ADMINISTRATIVE APPLICATION CHECKLIST

[D] Other: Specify: AMEND SWD-1420 BASED ON APPLICANT SUBMITTAL

OXY
API-30-025-26976
NBR Well #1
SWD-1420-A

From: Goetze, Phillip, EMNRD
Sent: Tuesday, July 23, 2013 2:56 PM
To: 'David_Stewart@oxy.com'
Cc: Joseph_Michael@oxy.com; Gonzales, Elidio L, EMNRD; Kautz, Paul, EMNRD; Ezeanyim, Richard, EMNRD
Subject: RE: OXY USA Inc. - NBR #1 SWD - 30-025-26976 - Recompletion to SWD

MAIN PASS 1000 PSI

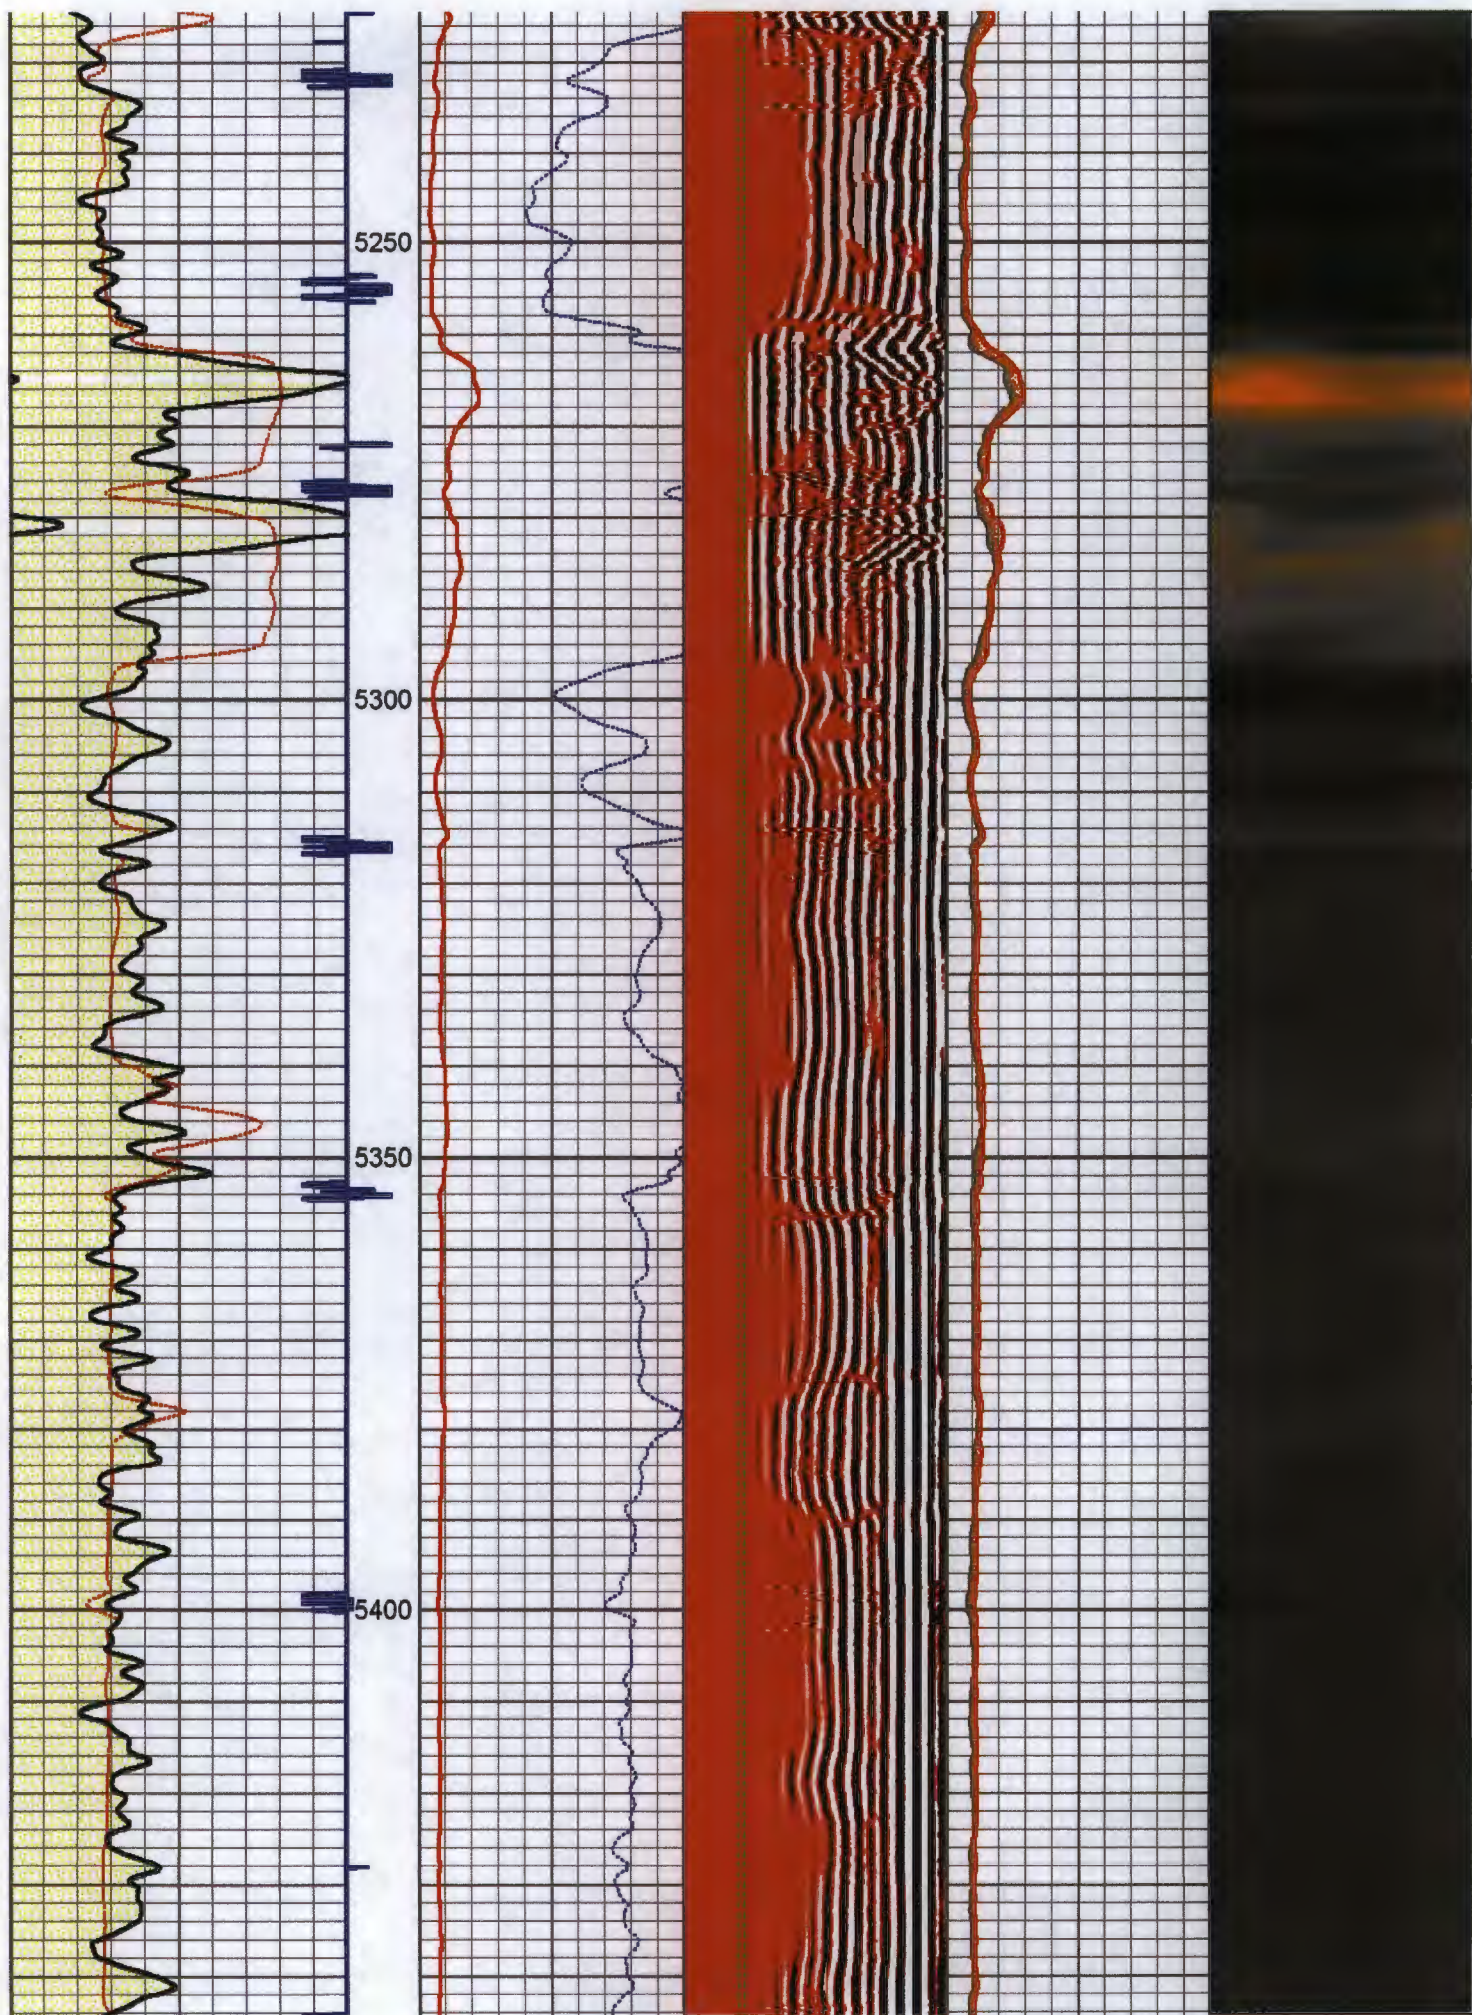
OXY has completed the plugback portion of the recompletion on our NBR #1 (30-025-26976) conversion to SWD. After we perforated and squeezed the 7-5/8" casing @ 5220' w/ 220sx cmt, a CBL was ran and shows the TOC @ 4710'. The SWD permit was approved for a top perf @ 4952', but OXY plans on the top perforation to be @ 5018'. Before we continue to complete the well, we would like to know if the TOC @ 4710' will be sufficient with the top perf @ 5018'. We are concerned about perforating the casing again to attempt to bring the cement up to 4500' as was originally proposed.

As mentioned on the phone, after reviewing the CBL, we TOC at 4,700'. For us to meet state regulation of 500' above top perf we would have to go back and do another cement squeeze. We want to perf between 5,018' – 5,280' as this is the best zone to inject into. The risk in doing that, is that we could potential perforate through 2 casing strings and if the cement squeeze isn't successful, we could create more damage by opening up a channel to contaminate fresh water.

The CBL shows that we have 300' of very good cement and should provide adequate isolation. Also above the Bell Canyon we have 100' of the Lamar which is a limestone and an Anhydrite zone, those 2 zones can also act as a barrier and will stop the frac from propagating upwards.

The package of information and the proposed changes in well construction have been reviewed with the Artesia District and with Richard Ezeanyim of the Engineering Bureau. It is OCD's opinion that the current TOC of 4710 ft for the 7 7/8-inch casing along with top perf being lowered to the proposed 5018 ft depth is sufficient to satisfy the requirements of the SWD permit. I will go and amend the existing permit to reflect the change in the top perf location and that the final TOC is acceptable.

You need to be aware: 1. that the packer will have to be located no shallower than 4918 ft based on the new shallow perf depth and 2. that the max surface inject pressure will increase to 1004 psi. Also, I need a clarification on the injection interval; you noted a lower perf of 5280 while the proposed C-108 completion showed 5998 ft for the lowest perf. Since I am amending the permit, what is going to be final interval, considering the planned life of the SWD well? Please provide some information regarding the last item. Thanks. PRG
